RE: *Meliadine Saline Effluent Discharge System Design Report and Drawings for 2AM-MEL1631 water licence*

250624 2AM-MEL1631 Design Report Meliadine Saline Effluent Discharge System
CIRNA Comments-IMLE

250624 2AM-MEL1631 Design Report Meliadine Saline Effluent Discharge System DFO
Comments-IMLE

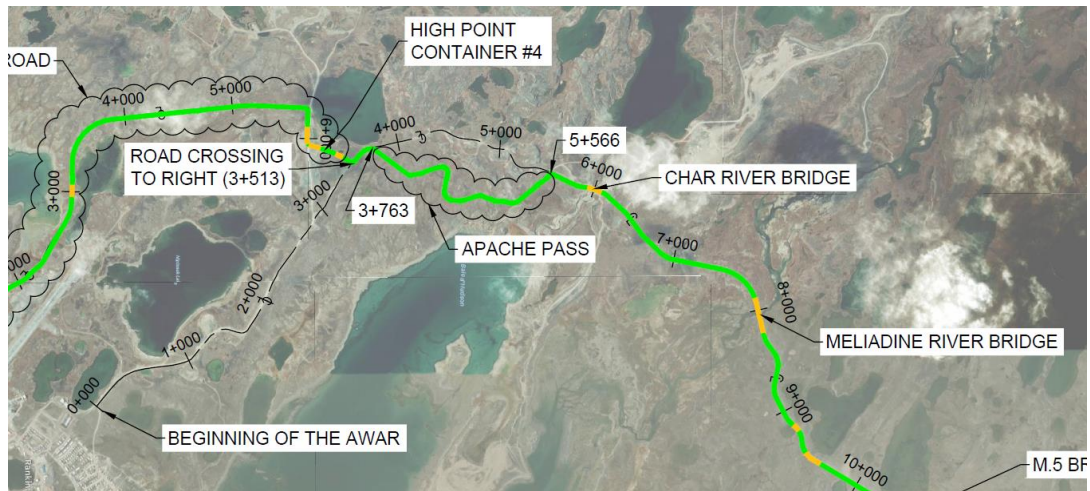
CIRNAC-1: APACHE PASS SECTION

Whether the proposed Apache Pass Section has been screened under the Nunavut Impact Review Board (NIRB) process, and if so, identify the screening decision or rationale for exemption.

If no new screening is proposed, explain how the existing NIRB Project Certificate authorizes the addition of this infrastructure.

This activity has been reviewed and approved through the 2020 FEIS Addendum process (i.e., the waterline). Questions on the routing were asked and answered during the NIRB hearing, and commitments were made.

The routing of the waterline, including routing around Apache Pass, went through an extensive NIRB review from 2020-2022. Therefore, yes, it has been screened by NIRB, and ultimately approved under Project Certificate No.006-Amendment 002 (March 2, 2022).
